Public Comment Submittal on the U.S. Department of Energy Draft Waste Incidental to Reprocessing Evaluation for the Test Bed Initiative Demonstration

Comment submittal by Tami Thatcher

Comments Due: February 2, 2022. Sent by email to: TBIWIR@rl.gov.

Figure 4-2. All-pathways effective dose equivalent 100 m downgradient from the Radioactive Waste Management Complex boundary from year 2110 to year 100,000 with cover infiltration rate equal to 1 cm/year.

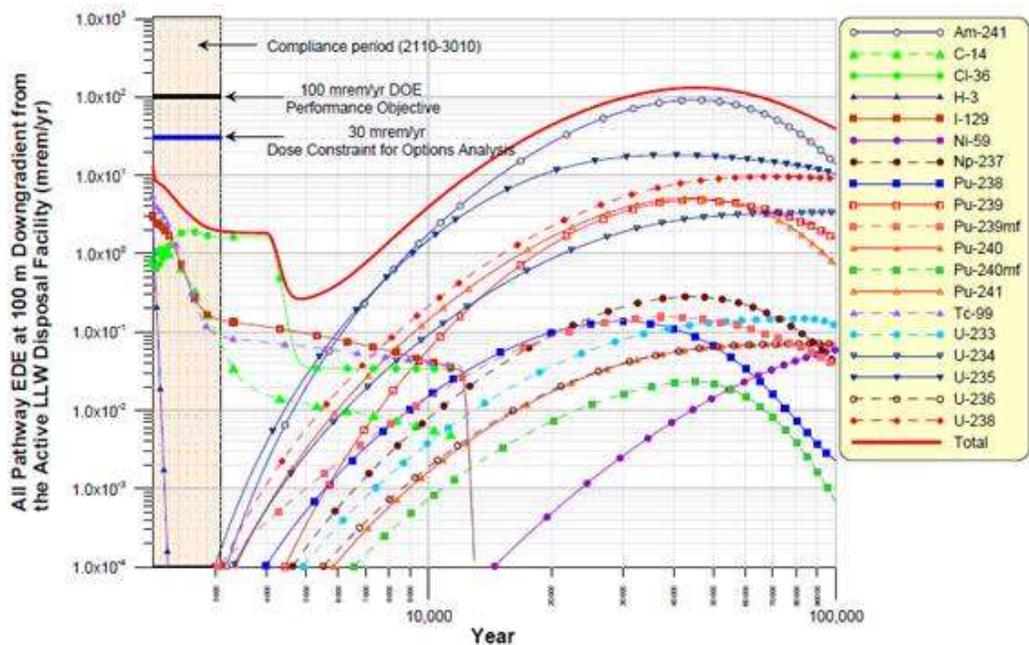
The DOE’s report summarizing the “forever contamination” at RWMC was never disclosed to the public prior to EDI’s freedom of information act request.³¹ A figure from the DOE’s report showing the rising radiation doses largely from migration of contaminants to the aquifer is shown in the figure below depicting the 100 mrem/yr case without credit for the soil cap slowing migration of contaminants to the aquifer.

The figure above shows the rising contamination levels after 10,000 years, with the leading Snake River Plain Aquifer contaminant being from americium-241. Please note the U.S. Environmental Protection Agency allows the Department of Energy to ignore and not display to the public the obscene radioactive contamination levels after 10,000 years at DOE cleanup sites.
